VIKING 80 CONVERTIBLE SEAKEEPER 40 REFITS

PRODUCT Seakeeper 40

Example:

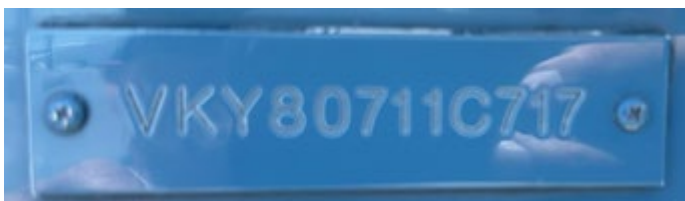
Effective with Hull 80-717, the Viking Factory made structural grid modifications to provide an alternate mounting location to accommodate the Seakeeper 35. With the launch of the Seakeeper 40 and an influx of Seakeeper 26 to 40 opportunities on the Viking 80C, it is vital to cross-reference the Hull Identification Number (HIN) to confirm if the vessel can accept a Seakeeper 40. All Viking 80 Convertibles with a hull number of 80-717 or later can accept a Seakeeper 40. Hulls built prior to 80-717 would require removal of the existing structural grid, with modifications to the rudderboard and installation of new foundation insert plates.

The HIN will be located on the upper starboard corner of the transom and contain the Viking hull number and year of manufacturing.

HIN 80739F122

Viking Hull #: [80-739](#)

Year: 2022

Capable of accepting a Seakeeper 40

HIN 80711C717

Viking Hull #: [80-711](#)

Year: 2017

Not Capable of accepting a Seakeeper 40
